**ETUDE PREPARATOIRE
RELATIVE AU
PROJET DE CONSTRUCTION DE LA
STATION DE DESSALEMENT D'EAU
DE MER A SFAX
EN REPUBLIQUE TUNISIENNE**

**RAPPORT FINAL
VOL. 2 : ANNEXES**

Minutes of Meeting
on
Inception Report
of
Preparatory Survey
for
Sfax Seawater Desalination Plant Construction Project in Tunisia

Minutes of Discussion
on
Interim Report 1
of
Preparatory Survey
for
Sfax Sea Water Desalination Plant Construction Project in Tunisia

Annex 4 : Plan of Scabed Soil Investigation for Marine Pipelines

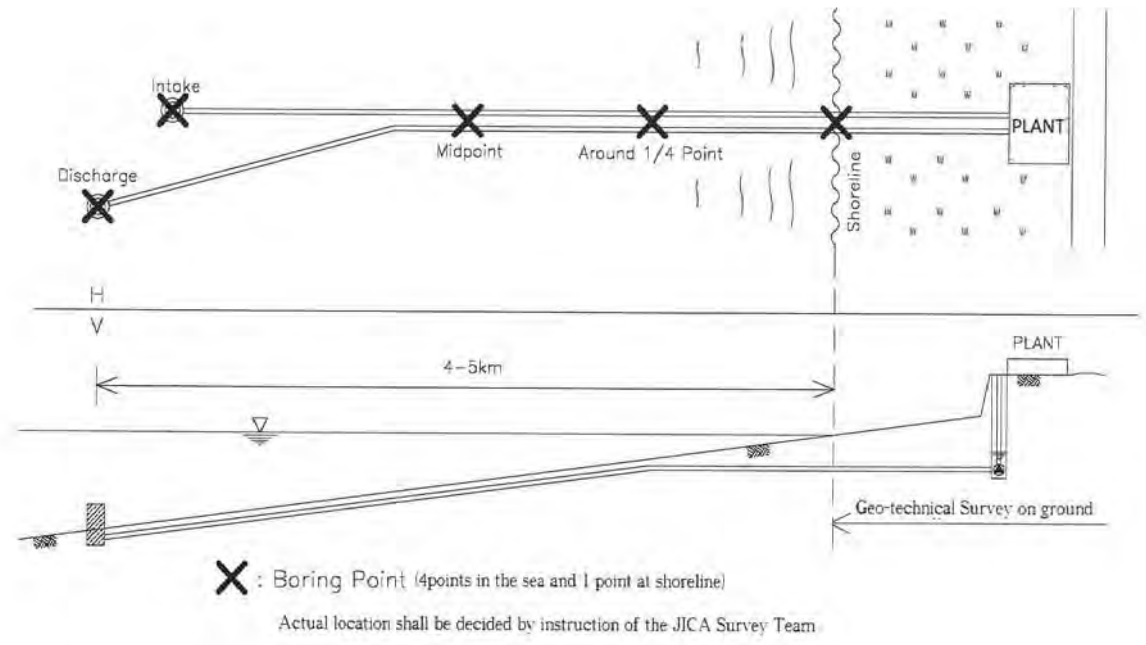
As a result of discussions, the Team stated that they will conduct the geotechnical survey at the ends of 2 marine pipelines, 1 point at the middle point of pipelines, 1 point at around 1/4 of the pipelines from the shoreline, and 1 point at shoreline. SONEDA agreed on the Team's plan (refer to Annex -4).
